OICA for PMP Meeting 09 Jan 2024

Content OICA for PMP Meeting

- Equivalency of Method B and Method D (CAN)
- Statement to Brake Particle filters
- Vehicle selection / Family building
- Fuel Cell vehicles

incl. Veh.12-16, OICA 20.12.2023

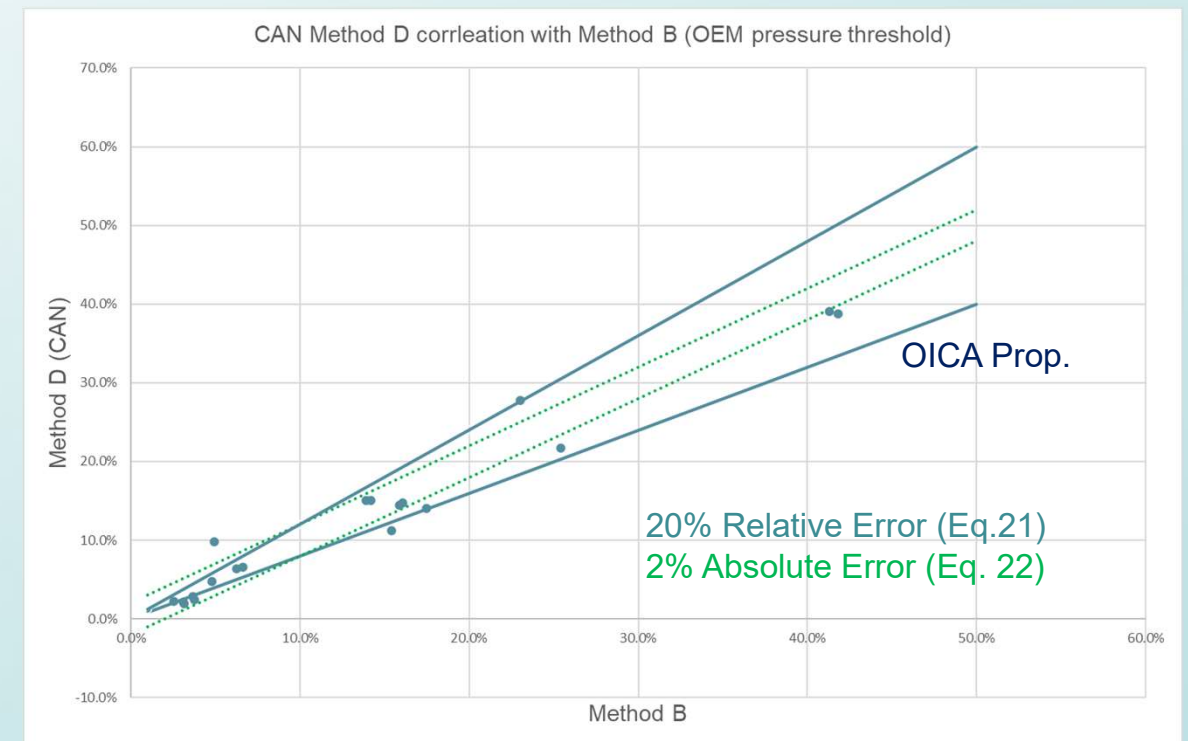
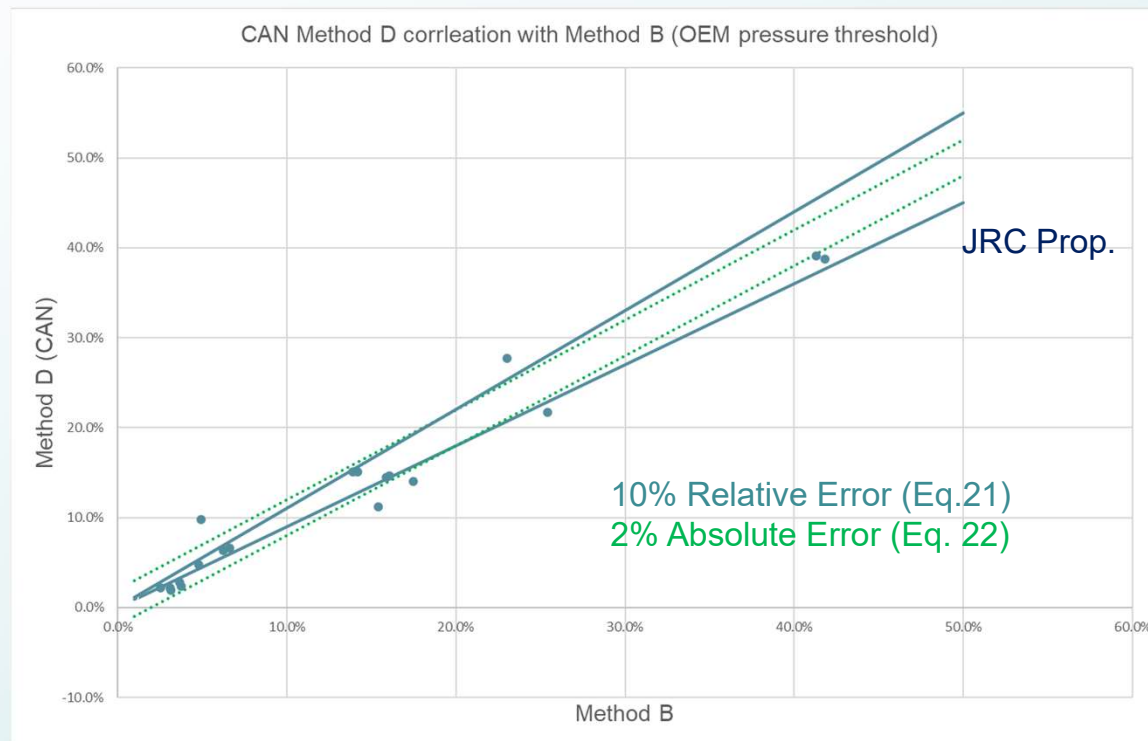
- JRC proposal: 10% relative error, or 2% absolute error.
- According to updated data the CAN method may fulfill the relative equivalency criterium (+-10%). The relative deviation criterion should be revisited in the second amendment when more data is available.
